PHASE 1 SCHEMATIC DESIGN

NSW DEPARTMENT OF
EDUCATION

NORTH SYDNEY PUBLIC
SCHOOL

SEC. 4.55 MODIFICATION ITEMS

1 PLAN
BUILDING I - LEVEL 3 FLOOR PLAN
SCALE: 1:100

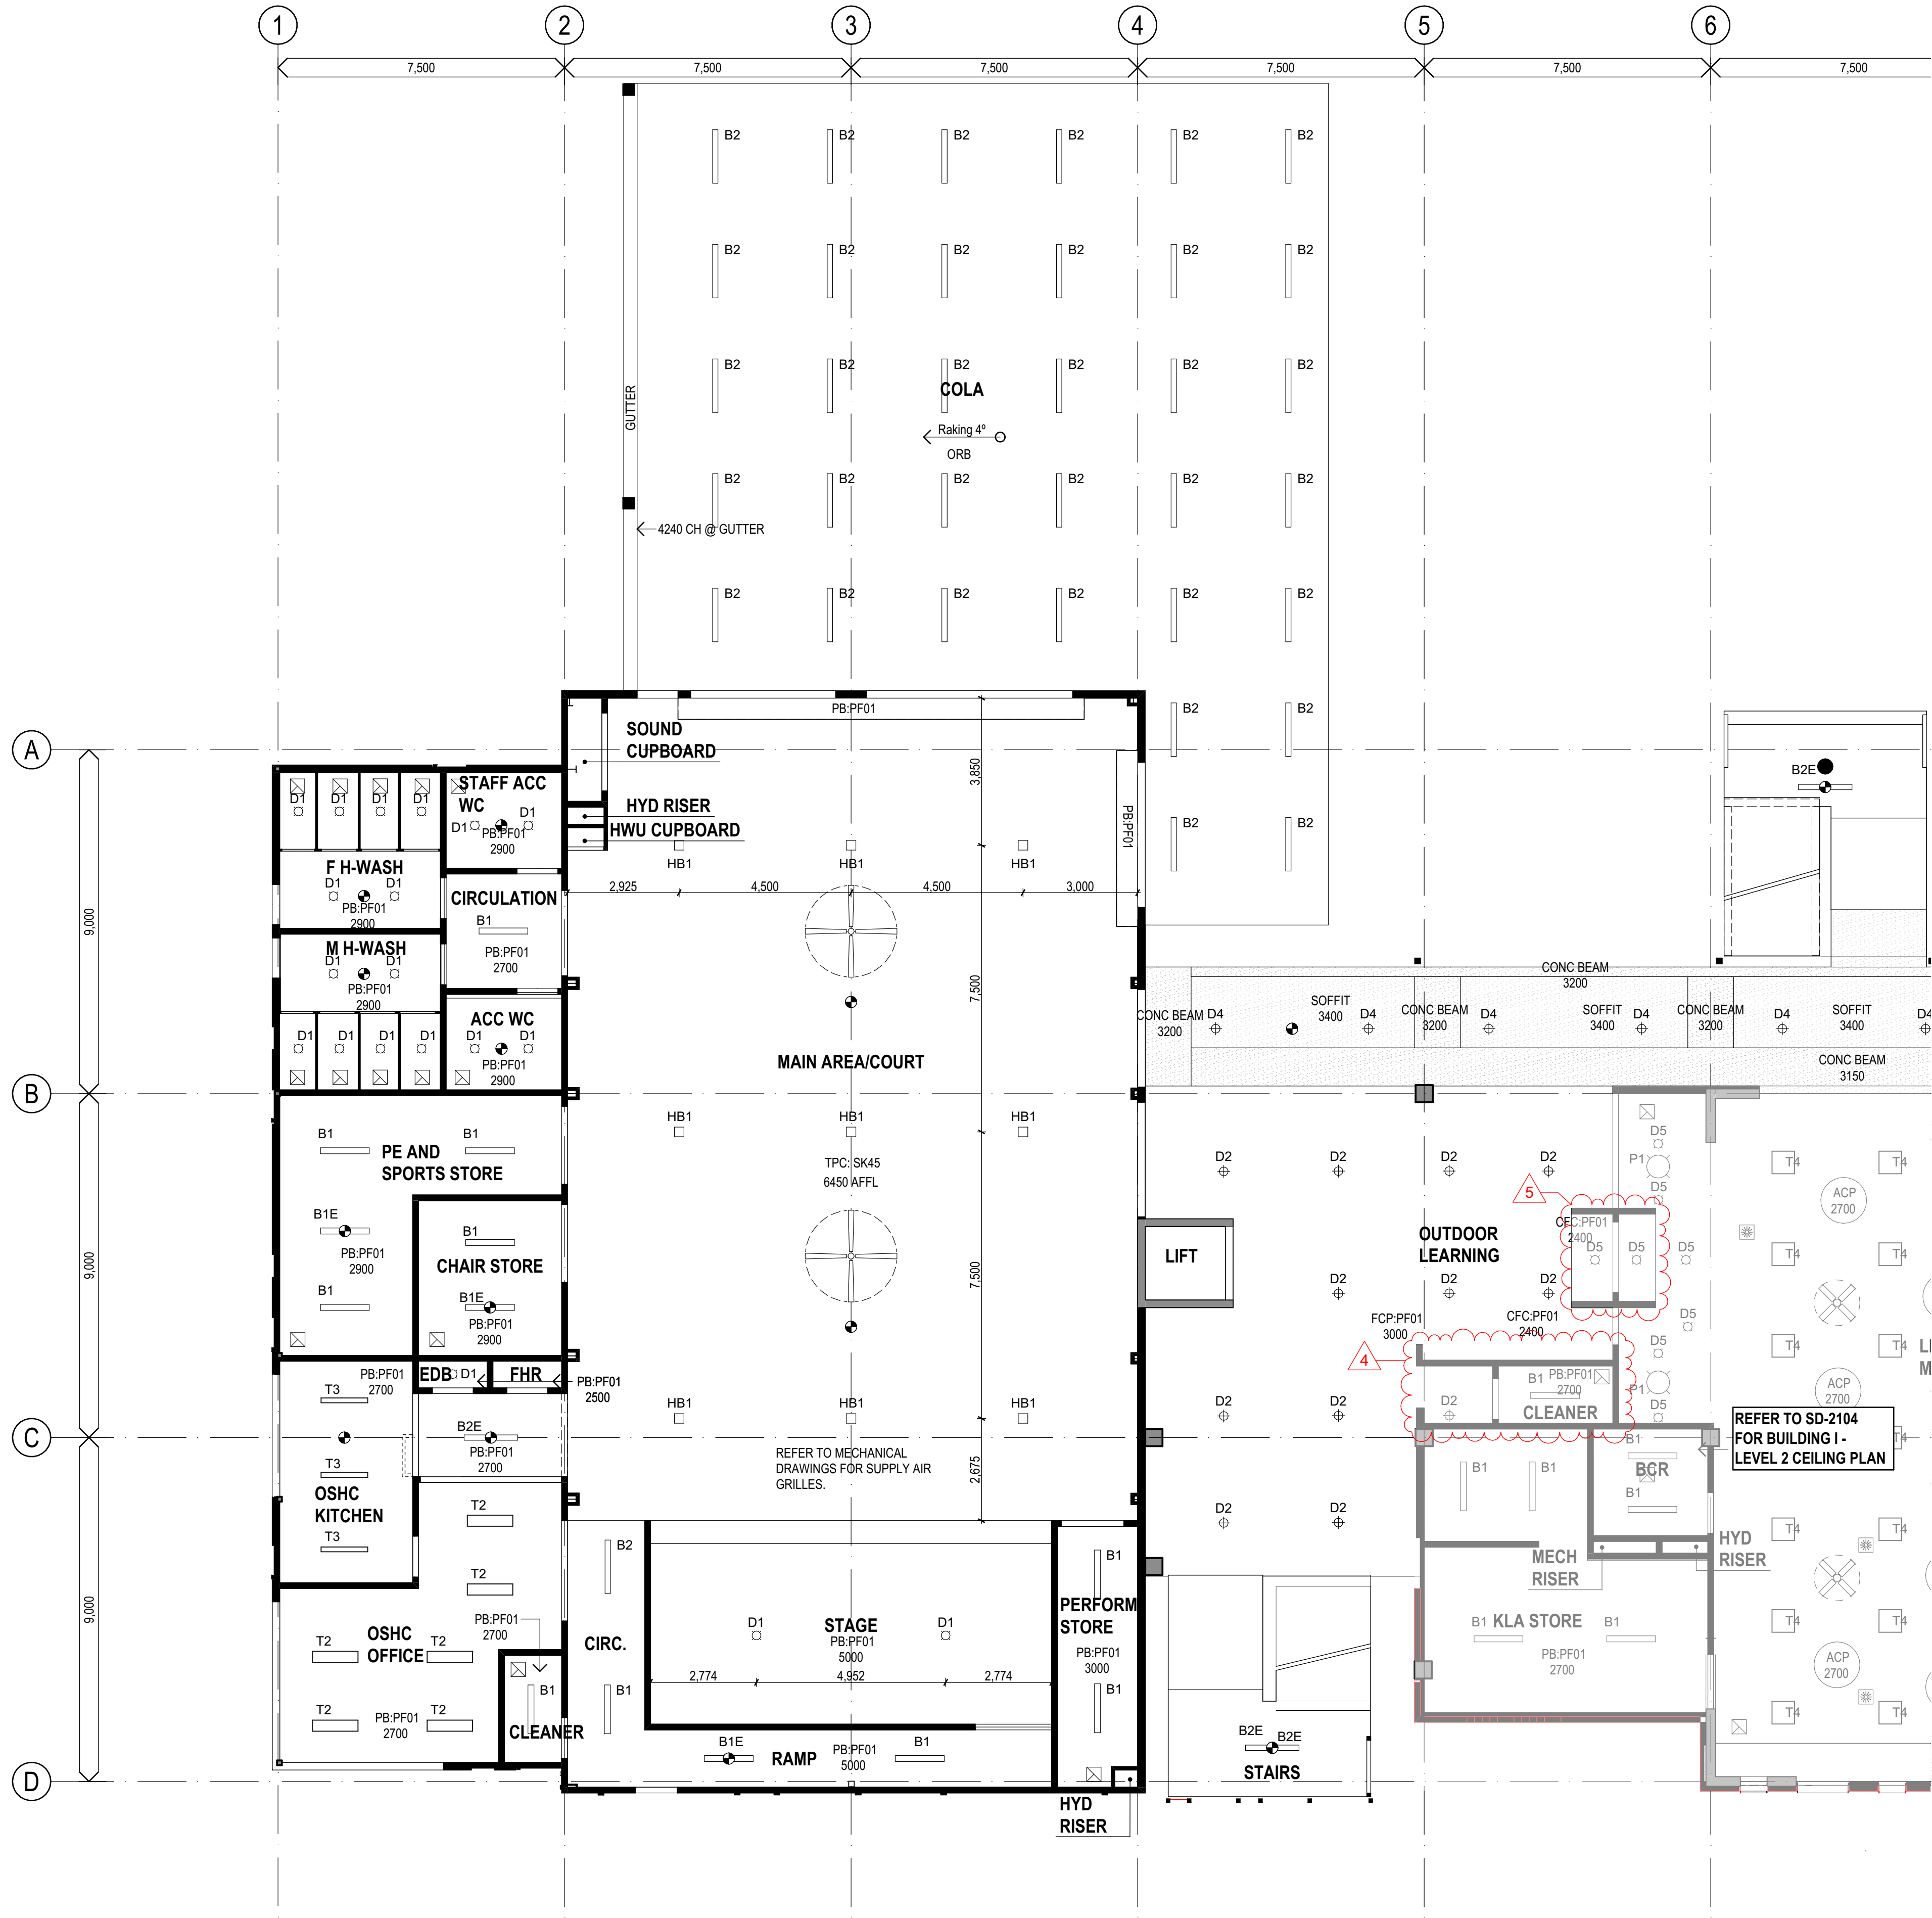
- ENTRY RAMP RECONFIGURATION TO BE 1:15, ADDITIONAL SLAB TO ACCESS PLANT ROOM
- HYDRANT BOOSTER LOCATION
- HERITAGE FENCE TEMPORARY REMOVAL
- ADDITIONAL CLEANER'S CUPBOARD
- LIBRARY ENTRY DOOR MOVED DUE TO CLEANER STORE BEING ADDED, NOW ALIGNS WITH LIFT
- WALL ALIGNMENT OF WC'S LEVEL 3
- WINDOW CHANGES TO BUILDING I SOUTH & EAST ELEVATIONS ON L1 / L2 / L3. WINDOWS INCREASED IN SIZE FOR COMPLIANCE WITH BCA PART F4 - LIGHT AND VENTILATION. FIXED GLAZED PANEL INTRODUCED TO LOWER SECTION OF L2 / L3 WINDOWS TO MEET MIN 1200MM SILL HEIGHT REQUIREMENT IN EFSG. LARGER OPENABLE AWNINGS INTRODUCED FOR NATURAL VENTILATION COMPLIANCE.
- LOUVERED DOORS CHANGE FROM SINGLE TO DOUBLE DOOR TO SUIT PLANT ROOM REQUIREMENTS.

1 PLAN
BUILDING I - LEVEL 2 RCP
SCALE: 1:100

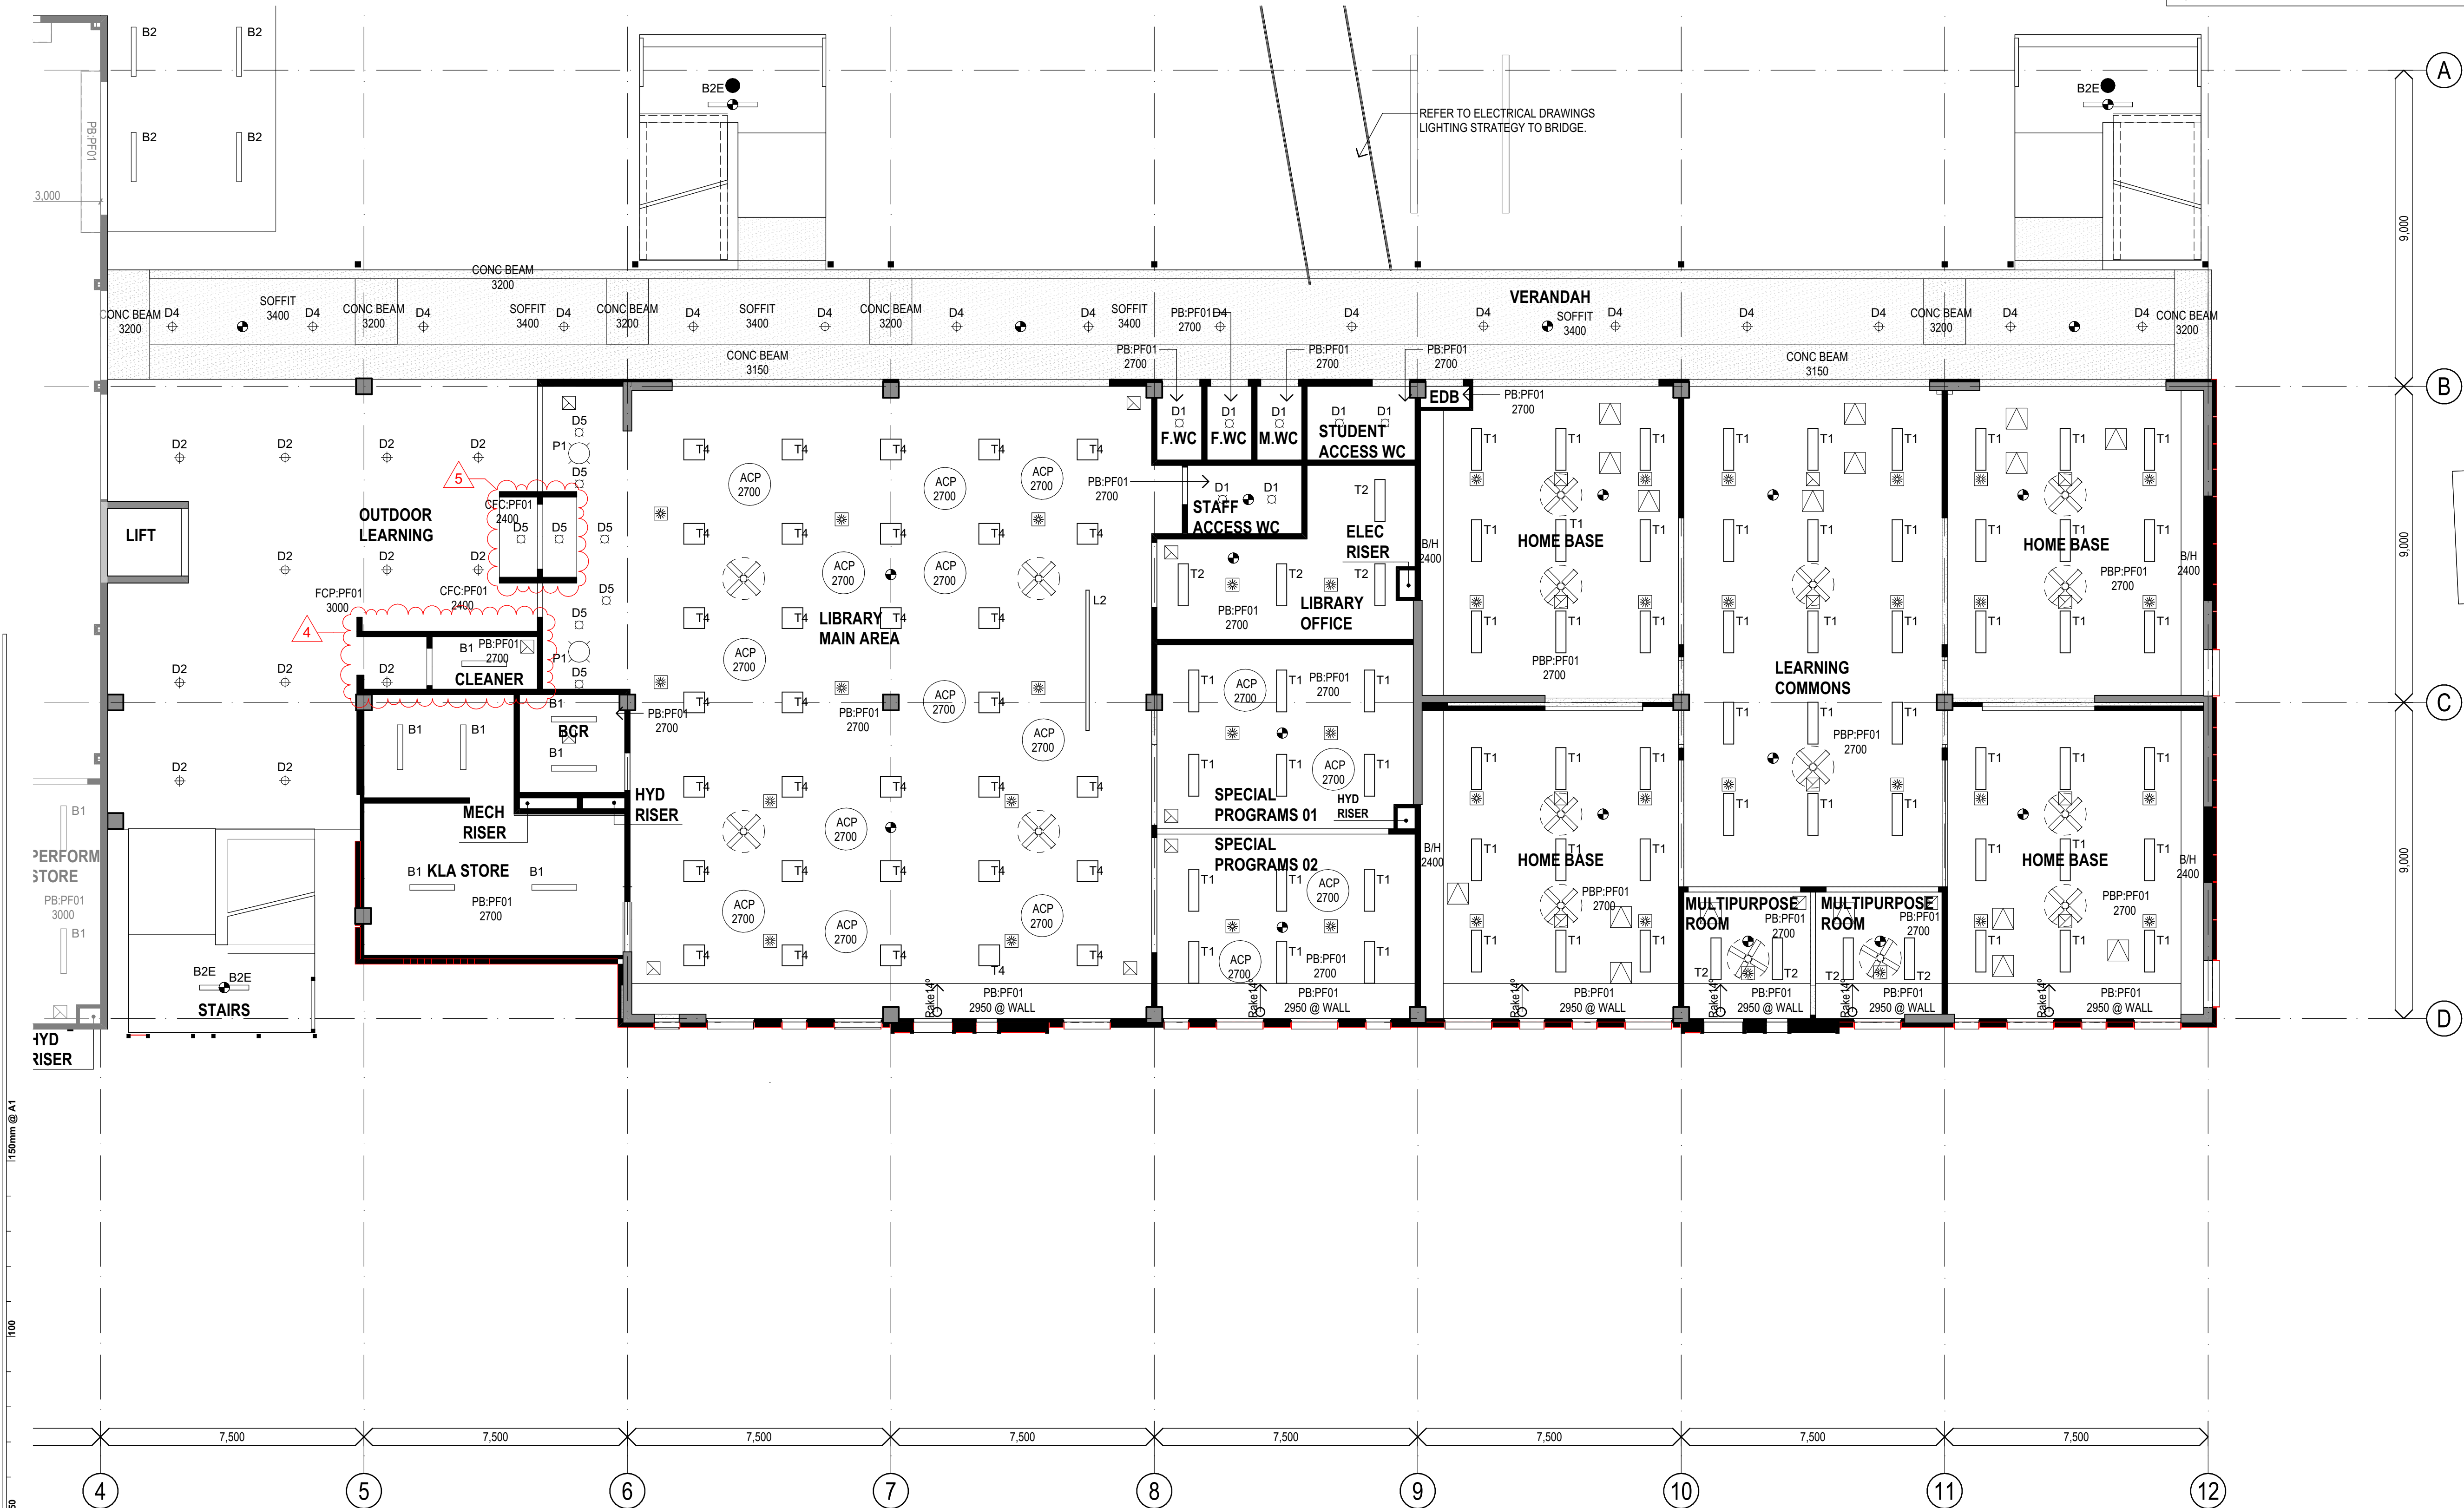
- ENTRY RAMP RECONFIGURATION TO BE 1:15, ADDITIONAL SLAB TO ACCESS PLANT ROOM
- HYDRANT BOOSTER LOCATION
- HERITAGE FENCE TEMPORARY REMOVAL
- ADDITIONAL CLEANER'S CUPBOARD
- LIBRARY ENTRY DOOR MOVED DUE TO CLEANER STORE BEING ADDED, NOW ALIGNS WITH LIFT
- WALL ALIGNMENT OF WC'S LEVEL 3

- WINDOW CHANGES TO BUILDING I SOUTH & EAST ELEVATIONS ON L1 / L2 / L3. WINDOWS INCREASED IN SIZE FOR COMPLIANCE WITH BCA PART F4 - LIGHT AND VENTILATION. FIXED GLAZED PANEL INTRODUCED TO LOWER SECTION OF L2 / L3 WINDOWS TO MEET MIN 1200MM SILL HEIGHT REQUIREMENT IN EFSG. LARGER OPENABLE AWNINGS INTRODUCED FOR NATURAL VENTILATION COMPLIANCE.
- LOUVERED DOORS CHANGE FROM SINGLE TO DOUBLE DOOR TO SUIT PLANT ROOM REQUIREMENTS.
